## HISTORIC AND DESIGN REVIEW COMMISSION

**HDRC CASE NO:** 2017-475  
**ADDRESS:** 1010 BURNET ST  
**LEGAL DESCRIPTION:** NCB 1660 BLK H LOT E 25 FT OF 3 & W 12.5 FT OF 4  
**ZONING:** R-6 H  
**CITY COUNCIL DIST.:** 2  
**DISTRICT:** Dignowity Hill Historic District  
**APPLICANT:** Markus Lopez  
**OWNER:** Ruben and Rebecca Lopez  
**TYPE OF WORK:** General Repairs; Window repairs; remove burglar bars; Replace front door  
**APPLICATION RECEIVED:** February 08, 2018  
**60-DAY REVIEW:** April 08, 2018  
**REQUEST:**

The applicant is requesting a Certificate of Appropriateness for final approval to:

1010 BURNET ST  
PROPOSED FLOOR PLAN  
3/16" = 1'-0"      1,536 SF

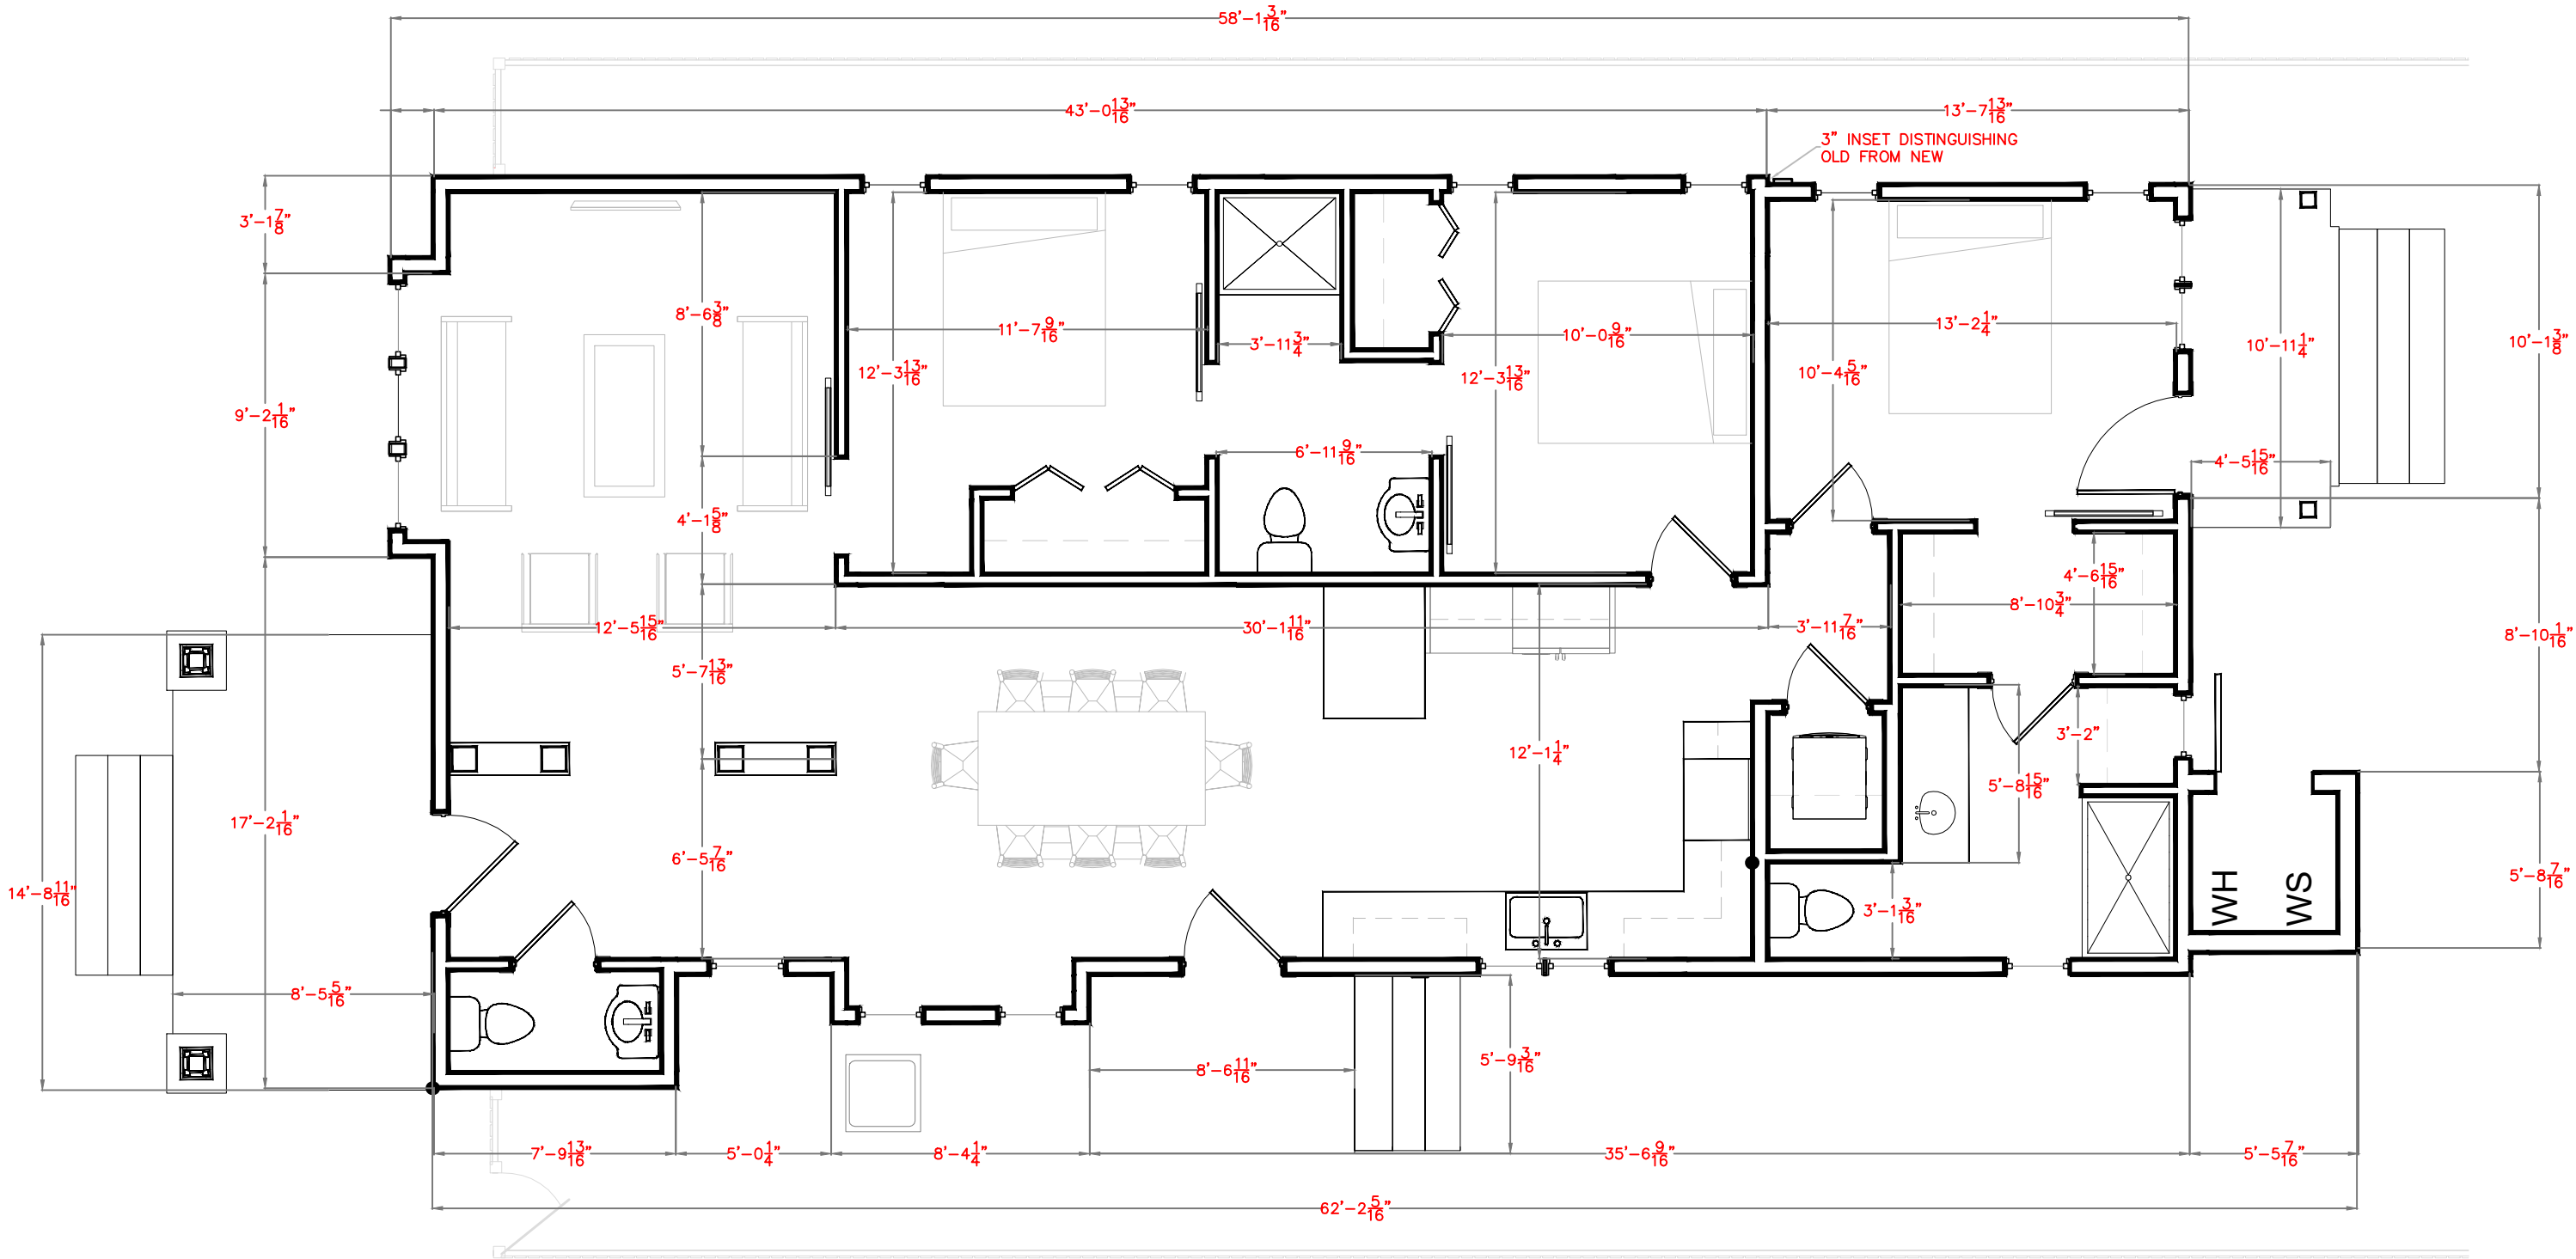
- c. **ADDITION** – The applicant has proposed to construct a rear-side addition to feature approximately 60 square feet. The Guidelines for Additions 3.1.A.i requires residential addition to be sited at the side or rear whenever possible. Guide lines 3.1.B.iv requires additions to respond to the size of the lot and to not double the existing building footprint. The proposed addition is consistent with the Guidelines.

2. That the proposed addition be more narrow than the existing house and be inset from the existing exterior wall planes. **The Owners have inset the new addition from the existing exterior wall planes by 3" – To distinguish between old and new.**

**1** Column Elevation Detail  
3/4" = 1'-0"

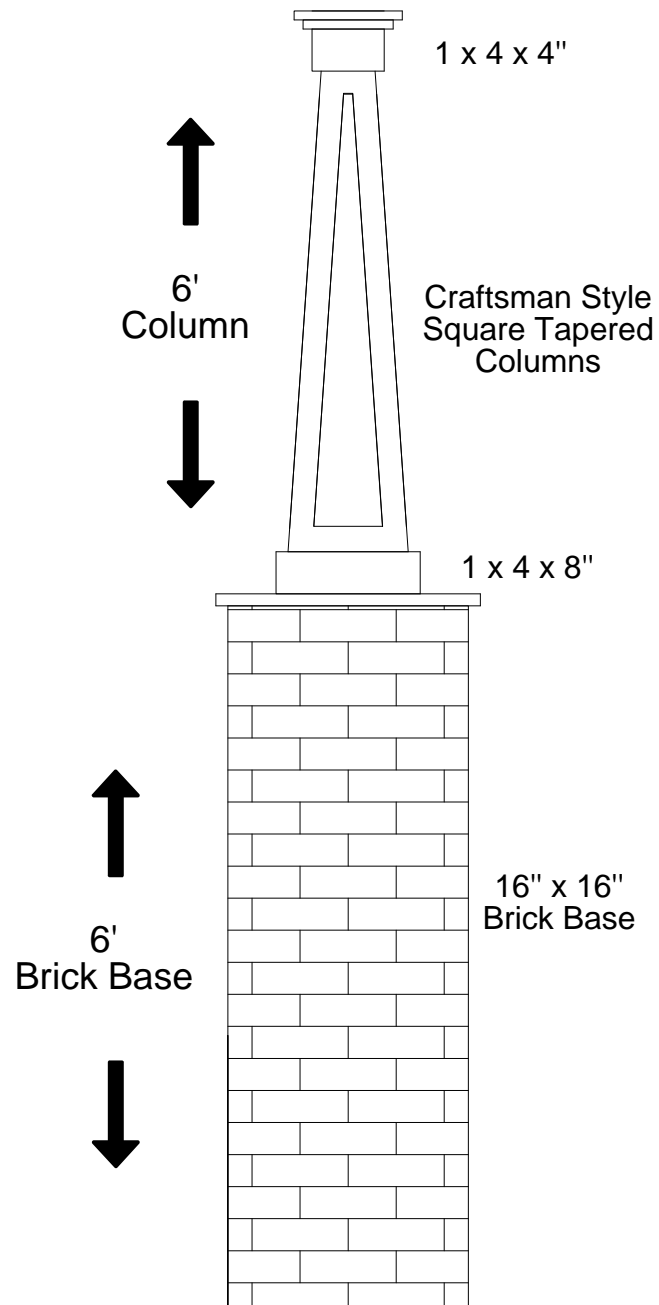
- b. **COLUMN REPLACEMENT** – The applicant proposed to replace the existing columns in the front porch with column details consistent with the historic character of the era in which the structure was built. The applicant has proposed to use tapered wood columns with brick masonry supports where linear wood columns currently exist. The Guidelines for Exterior Maintenance and Alterations 2.B.iii. requires designs to be compatible in scale, massing, and detail while materials should match in color, texture, dimensions, and finish when in-kind replacement not feasible. While staff finds that in-kind replacement of the linear wood columns feasible, the applicant's proposed design is generally appropriate given the context of the neighboring structures. However, staff finds that a wood base and a slightly wider column rather than the proposed brick base and narrow column is would be more consistent with the Craftsman style of the structure.

Staff recommends final approval of all items based on findings b through j, with the stipulation that the replacement columns feature a wood base and dimensions that are more consistent with the Craftsman architecture style. The applicant is to submit a detailed drawing of the proposed columns to staff for review and approval.

Rear Addition Perspective

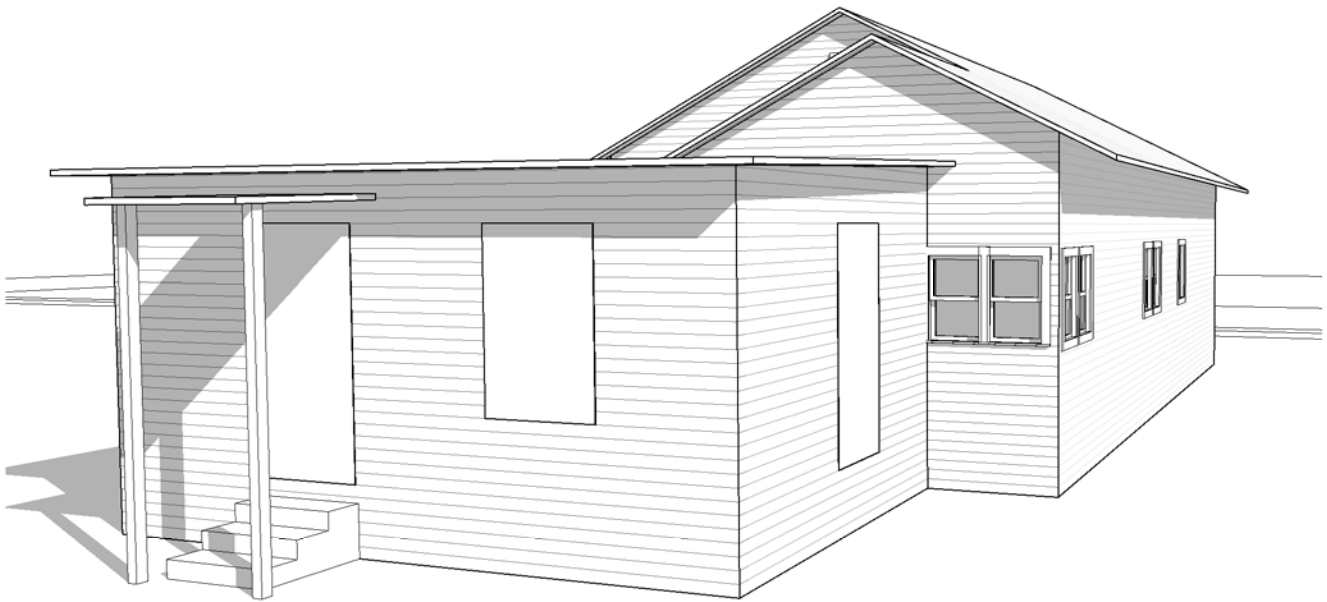
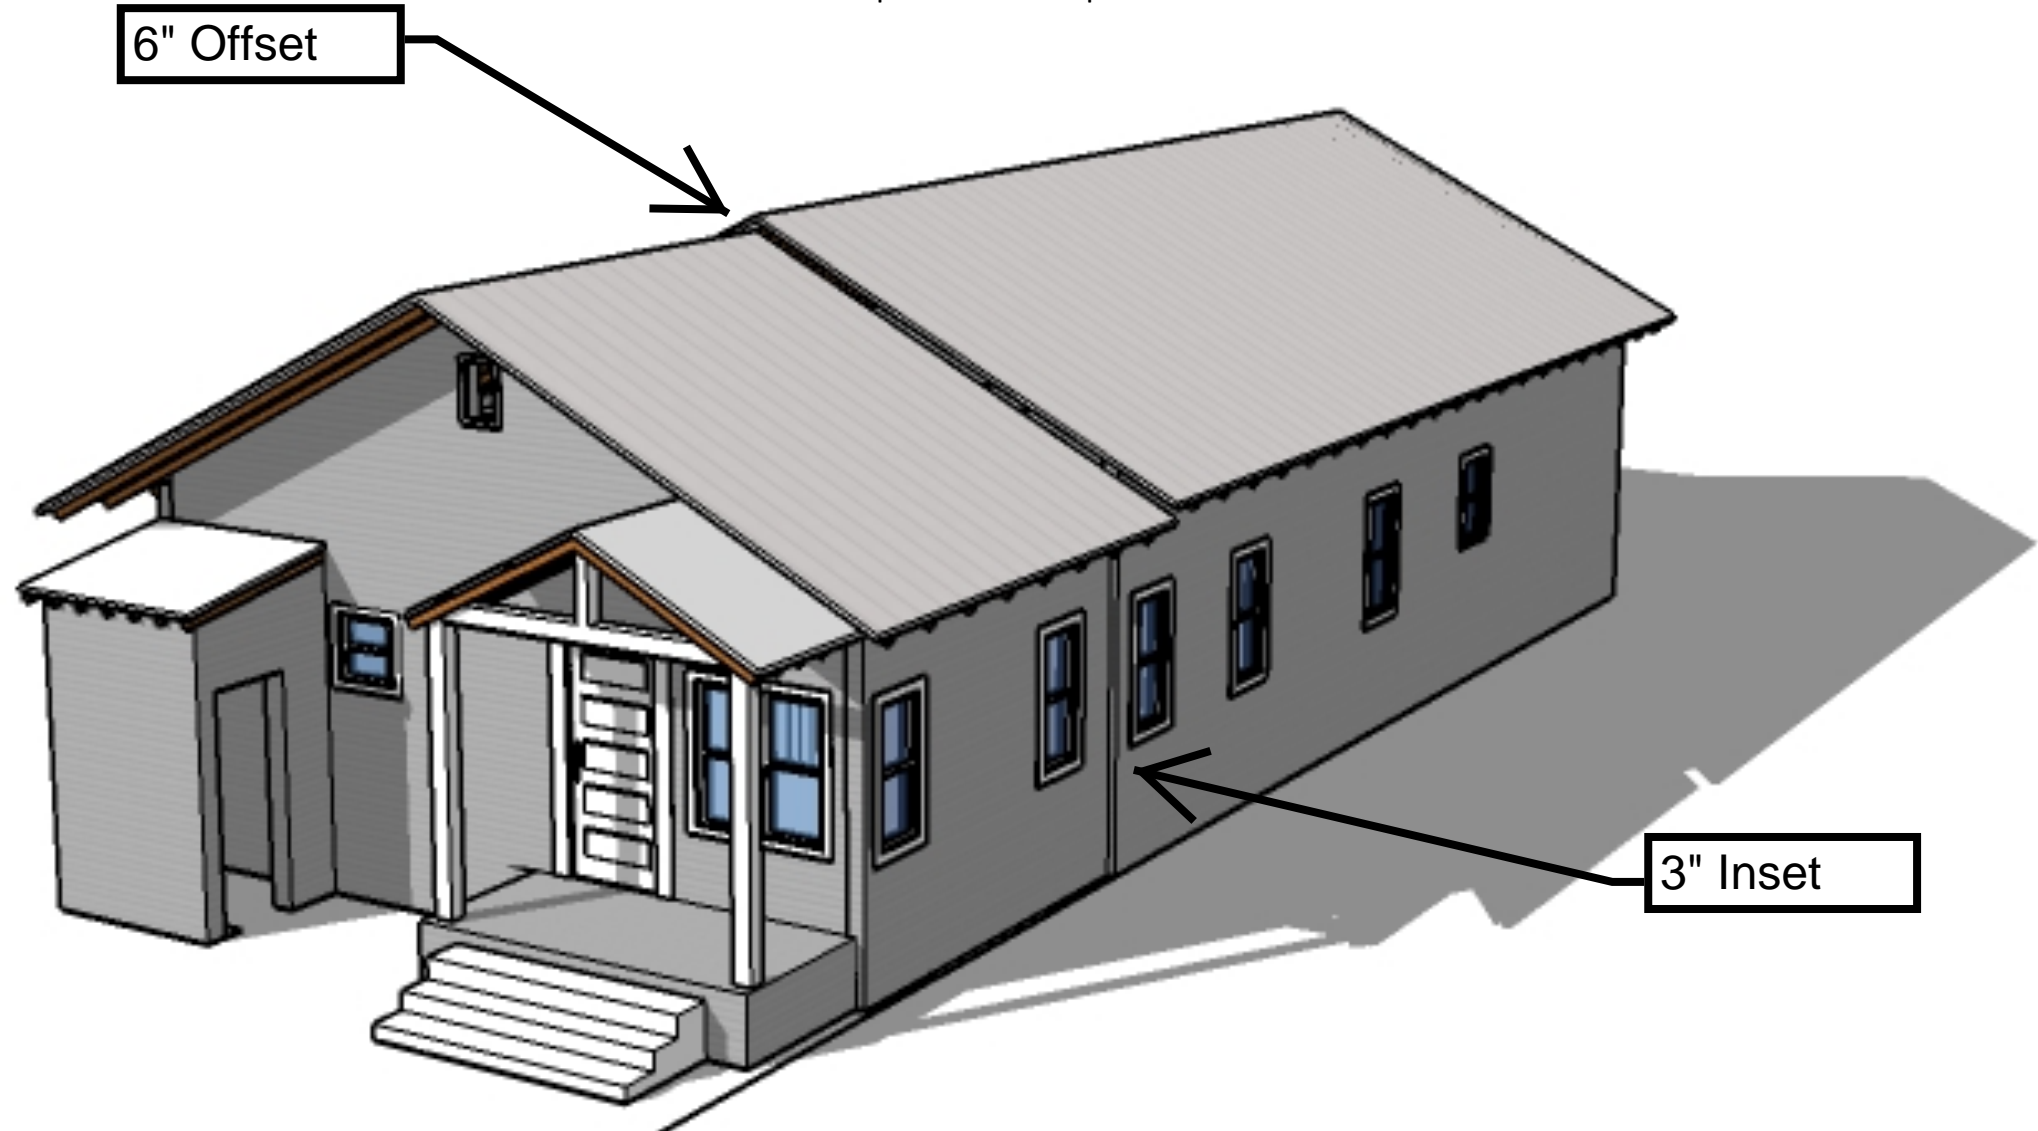
- d. **TRANSITION BETWEEN OLD AND NEW** – According to the Guidelines, new additions should utilize a setback or recessed area and a small change in detailing at the seam of the historic structure and new addition to provide a clear visual distinction between old and new building forms. The applicant has met the stipulation provided during conceptual approval by inseting the proposed roof from the existing roof by six (6) inches and the proposed addition from the historic structure's exterior wall planes by three (3) inches.

- e. **ROOF FORM** – The applicant has proposed to demolish the secondary gable roof and flat roof over the rear of the structure and to expand the existing primary gable roof over the existing rear and the proposed addition. The Guidelines for Additions 3.1.A.iii requires the utilization of similar roof pitch, form, overhang, and orientation as the historic structure for additions. Staff finds the demolition of the secondary roofs and the expansion of the primary roof in respect to the proposed addition appropriate.

1. The new roof form must be offset and subordinate to the historic structure's primary gable roof. **The Owners offset the new roof 6" below the structures primary gable.**
